Docket Item # 23  
BAR CASE #2005-0303

BAR Meeting  
March 21, 2007

**ISSUE:** Concept approval of two new buildings  
**APPLICANT:** Armed Forces Benefit Association  
**LOCATION:** 909, 901, & 919 North Washington Street  
**ZONE:** CD/Commercial

Figure 2: Surrounding Height Relationships

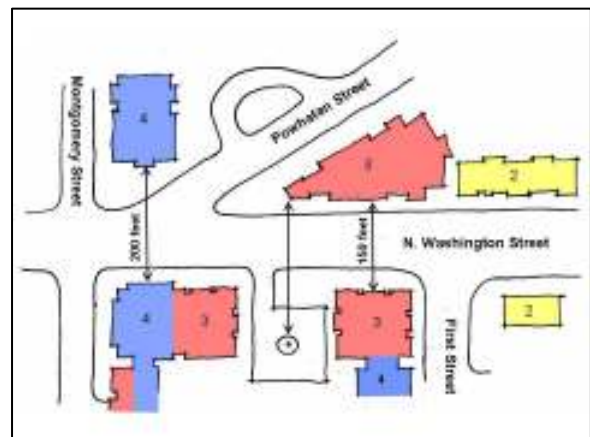
Staff is recommending that the proposal be revised from all four story buildings on Washington Street to predominantly three stories on Washington Street. The three level buildings will be more consistent with the predominant scale of this section of Washington Street and with the one and a half to two and a half story buildings and townhouses to the north. While staff is recommending that Washington Street be predominantly three stories, a portion of the proposal on Washington Street could be four levels. Staff recommends that if a four story portion of the building is proposed on Washington

Street that the taller portion should occur at the intersection of Washington and Montgomery Streets due to the width the street at this intersection. A four-level building at this location would provide an appropriate relationship between the 900 N. Washington proposed building, the American Association of Physicians Assistants (AAPA) building and this intersection. The proposal should also explore the possibility of a setback from the corner of North Washington Street and First Street to provide more green space on First Street, consistent with previous BAR recommendation.
